In re Application for Reissue
of U.S. patent No. 5,462,120

Title: DOWNHOLE EQUIPMENT, TOOLS
AND ASSEMBLY PROCEDURES FOR THE
DRILLING, TIE-IN AND COMPLETION OF
VERTICAL CASED OIL WELLS
CONNECTED TO LINER-EQUIPPED
MULTIPLE DRAINHOLES

REVISED AMENDMENT C AND REQUEST FOR AN INTERFERENCE

FIG.10
(Amended)

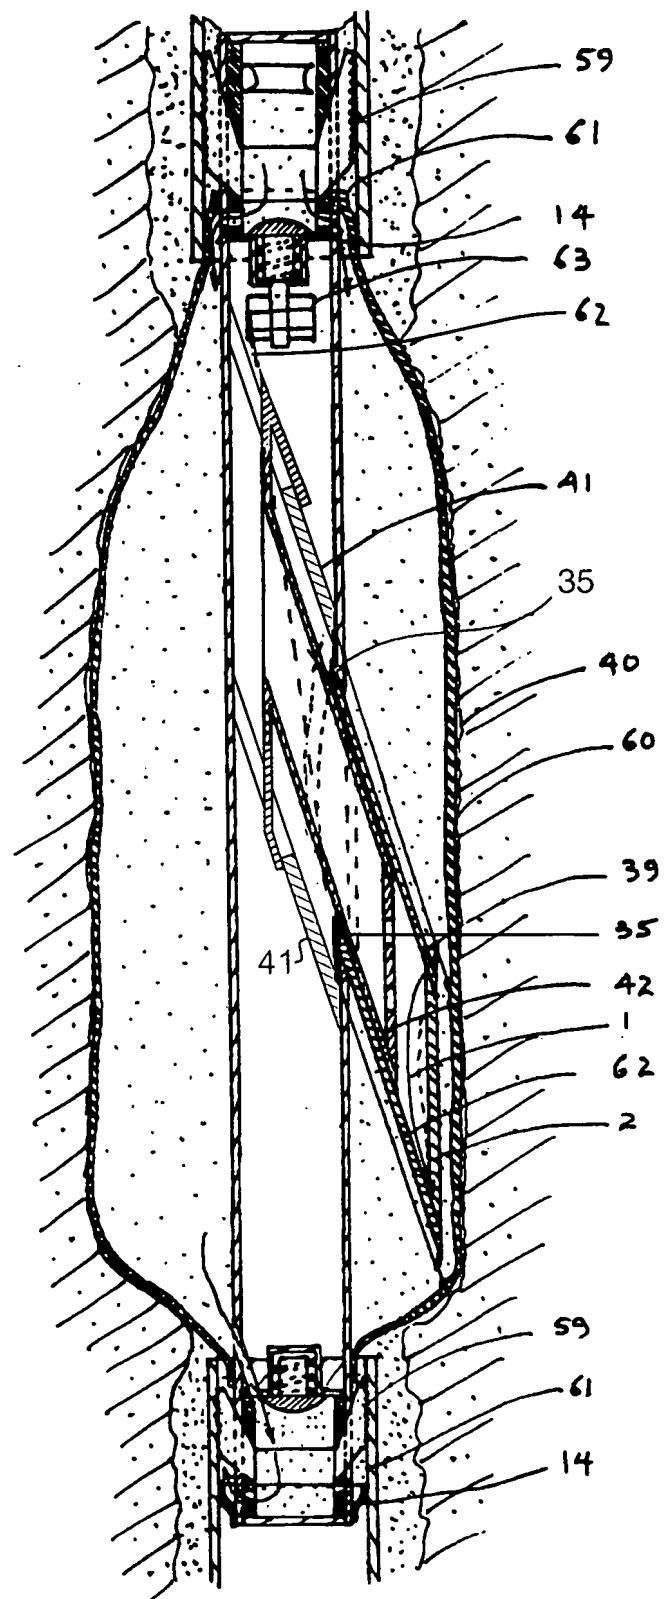
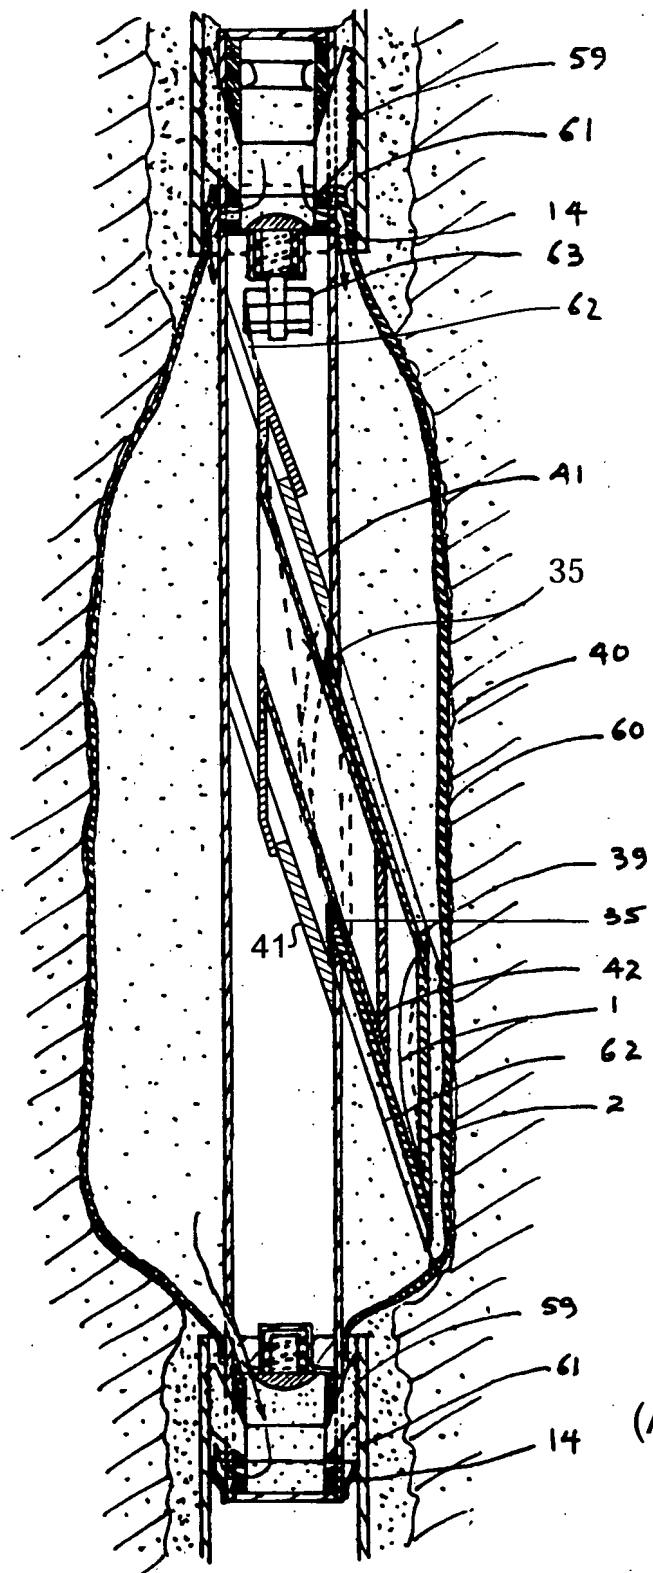
With further respect to claims 50-52, these claims all depend on claim 49. Applicant refers to the embodiment of figures 4 and 10 to provide support for the limitation recited in claim 49. However, the embodiments of Figures 4 and 10 do not include the “flange orientating means” that include mating key and groove as recited in claims 50-52. The “flange orientating means” or “groove and mating key” are associated with the embodiment of Figure 3a, NOT figure 4 or 10.

Claims 3, 4/3, 56/3, 23, 35, 198-203, 211 and 212 are either directly or indirectly related to telescopic liner stubs shown in Figure 4 or Figure 10. However, it is not seen how the liner stubs shown in Figures 4 and 10 of the drawings can operate as disclosed in the specification or claimed. As shown in these figures, the collar (or flange) and sealing gasket are provided on the upper end of the inner mobile guide 42, not on the liner stub 39. The collar (or flange) and sealing gasket therefore cannot engage with the periphery of the pre-machined window as recited. Further, since the liner stubs 39 are closely fitted between outer fixed tubular cages 41 and inner tubular mobile guides 42, any collar (or flange) and sealing gasket on the upper end of the liner stubs 39 would engage the upper end of the outer fixed cage 41 and prevent further downward movement of the liner stub 39 into contact with the periphery of the windows as recited. Furthermore, the sealing gasket shown in Figure 4 as being on the inner surface end of the collar or flange 35 obviously cannot engage the periphery of the window as recited.

Claim 13: Applicant pointed out that it has support in embodiments of Figures 3a, 4 and 10. However, the examiner's view is that figures 4 and 10 do not provide support for this claim because Figures 4 and 10 involve a liner stub, not liner as called for in intervening claim 9.

It was agreed that the proposed drawing corrections to Figures 4 and 10 in the attached sheets have support in the original disclosure, e.g., column 8, lines 54-67, column 9, lines 1-3 and Figure 3a, column 7, line 67 through column 8, line 11; Figure 10; column 16, lines 17-44. Applicant will correct the drawings as agreed and will submit a supplemental amendment to correct 35 USC 112 matter in claims 217, 221, 239 and 248. The words "such as" will be avoided in claims 217, 239 and 248. The words "tubular member" in claim 221 will be changed to --liner--.

Pursuant to 37 CFR § 1.121, Applicant requests approval of the attached drawing changes. Applicant has submitted these changes by way of a new sheet of drawings with Figs. 4 and 10 identified as amended. 37 C.F.R. § 1.121(b)(3)(i). Moreover, these drawings constitute a sketch in permanent ink and the proposed changes are shown in red. 37 CFR § 1.121(b)(3)(ii). Upon receiving approval of these drawings, Applicant will submit formal drawings.

FIG.4
(Amended)

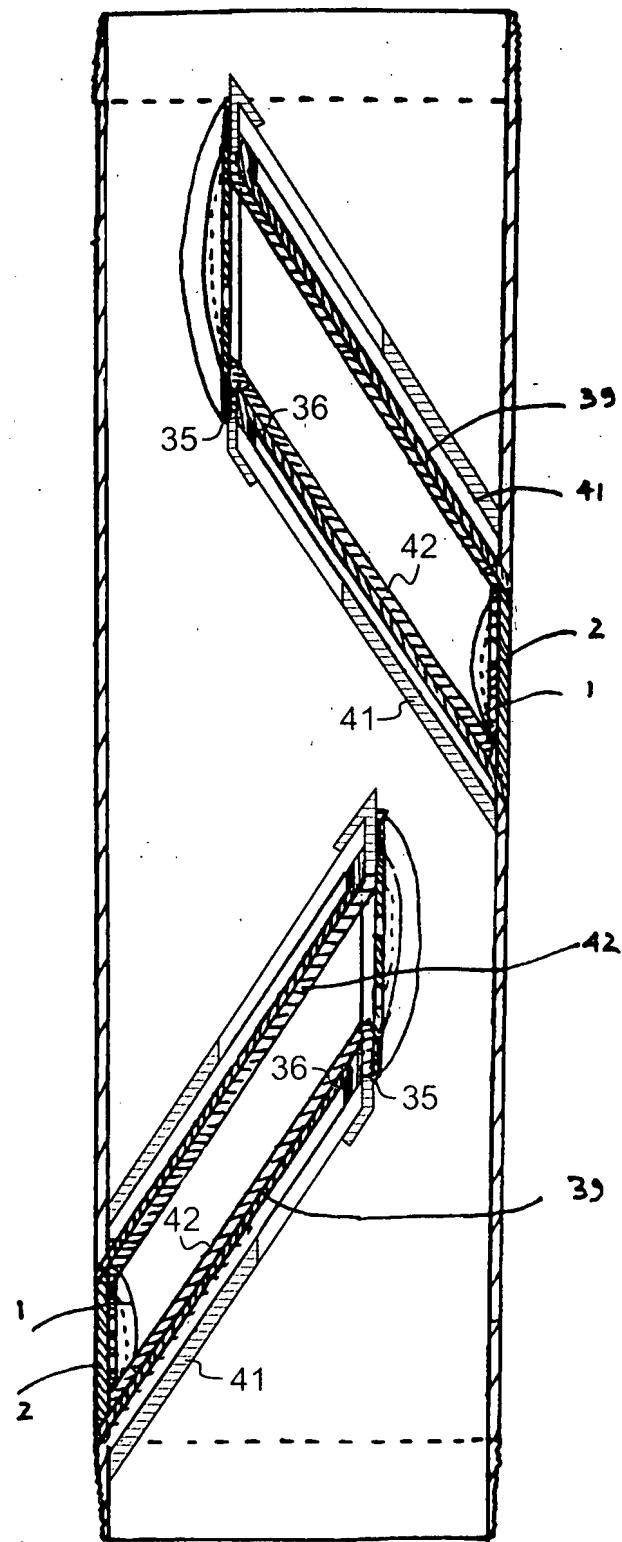
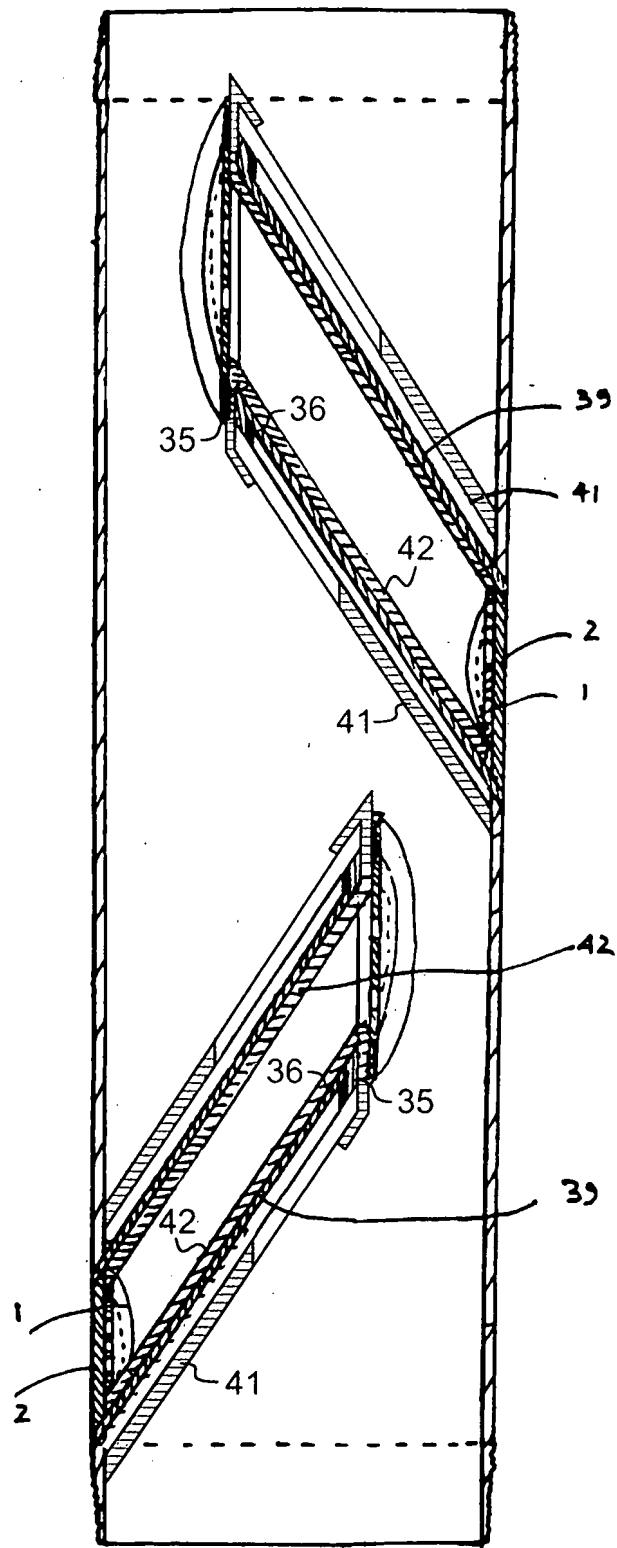
As for claims 198-203, 211 and 212, there are no embodiments in the original disclosure which have all of the limitations as recited in these claims. For example, only the embodiment shown in Figure 4 or 10 meets the limitation of "said pipe being maintained substantially within said housing during run in" or "maintaining said tubular member substantially within said housing during run in" recited in these claims. However, this embodiment does not include a first window having a periphery and a second borehole extending from the first borehole coextensive with the first window. It is noted that the embodiment of Figure 3a that applicant states in the Claim Chart (Appendix G) as having the "flange" as recited in these claims is not "maintained substantially within said housing during run in" as also called for in these claims. The underreamed portion of case cannot properly be considered as the "first window" as now recited in these claims because there is not an "opening" that extends through the casing or wellbore's wall. Further, this underreamed portion is not ~~is not~~ coextensive with the second borehole. The diameter of the second borehole is much smaller ^{than} the thickness of the underreamed portion.
